AMENDMENT OF SOLICITATION/MODIFICATION OF CONTRACT				1. CONTRACT ID CODE <div style="text-align: center;">J</div>		PAGE OF PAGES <div style="display: flex; justify-content: space-between;"><div>1</div><div>21</div></div>

2. AMENDMENT/MODIFICATION NO. <div style="text-align: center;">0004</div>		3. EFFECTIVE DATE <div style="text-align: center;">22-Oct-2003</div>		4. REQUISITION/PURCHASE REQ. NO. <div style="text-align: center;">W81G67-3036-4923</div>		5. PROJECT NO.(If applicable) <div style="text-align: center;">DACW37-03-B-0007</div>

6. ISSUED BY <div style="font-size: small;">CONTRACTING DIVISION USACE - ST. PAUL 190 5TH STREET E ST. PAUL MN 55101</div>		CODE <div style="text-align: center;">W912ES</div>		7. ADMINISTERED BY (If other than item 6) <div style="text-align: center; font-weight: bold;">See Item 6</div>

14. DESCRIPTION OF AMENDMENT/MODIFICATION (Organized by UCF section headings, including solicitation/contract subject matter where feasible.) The bid opening date remains unchanged. Bid Item numbers 10 and 12 are changed. Drawings and Specifications are changed.							
Except as provided herein, all terms and conditions of the document referenced in Item 9A or 10A,

MSE1

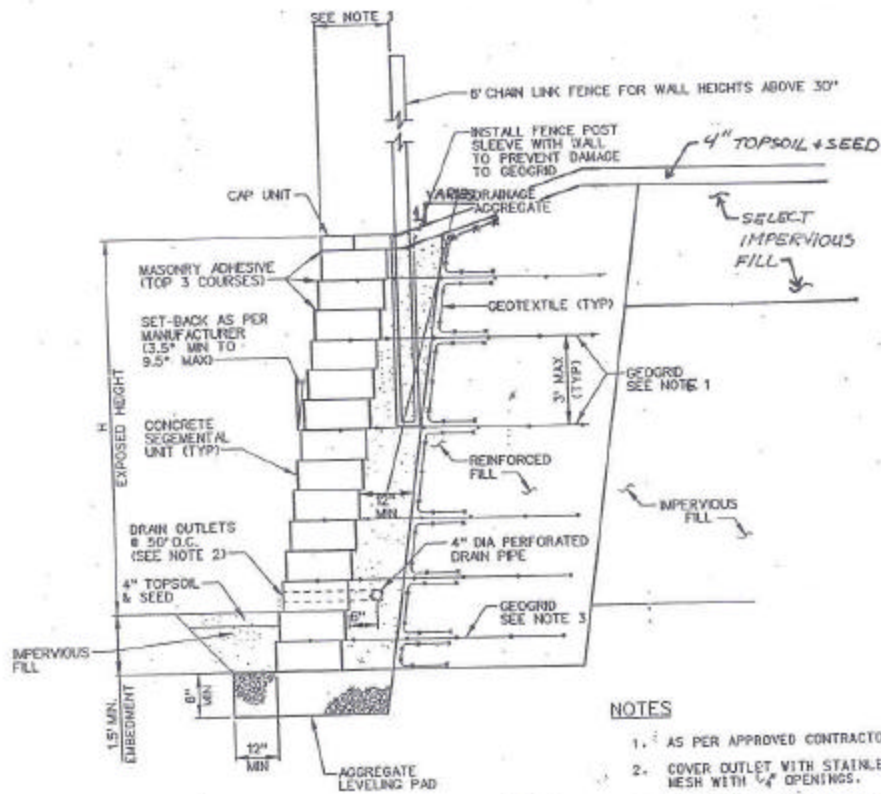
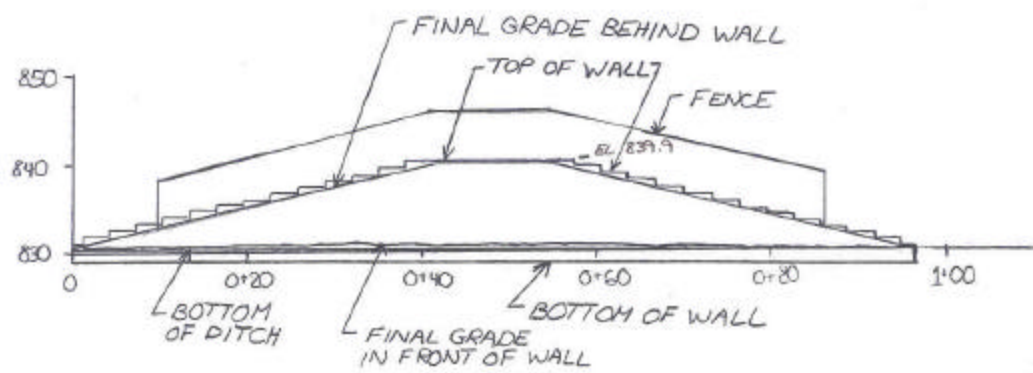
1. Drawing R-P-GF-64/1581, Profile – 48" Detention Pond Outlet. The profile indicates 12" of R20 Riprap in the North Micropool. Riprap in the North Micropool shall be limited to that required for the RCP apron. Typical Detail for Riprap at RCP apron is shown on drawing R-P-GF-64/1733 (sheet 171). Riprap type shall be R20.
2. Drawing R-P-GF-64/1565, Coordinate E5 and Note 4. Delete reference to note 4 and delete note 4. Power poles will remain in place. An MSE wall (Segmental Block Retaining Wall) shall be constructed around the power poles as shown in the attached sketches (MSE1, MSE2, and MSE3).
3. Drawing Number 64/1562: Coordinate E1. Add the following note to the drawing:

1. AS PER APPROVED CONTRACTOR DESIGN.
2. COVER OUTLET WITH STAINLESS STEEL MESH WITH 1/4" OPENINGS.
3. REQUIRED GRID LOCATION, MINIMUM GRID LTOS EQUAL TO 1600 LB/FT. MINIMUM GRID LENGTH EQUAL TO 9 FEET BASED ON GLOBAL STABILITY REQUIREMENTS.
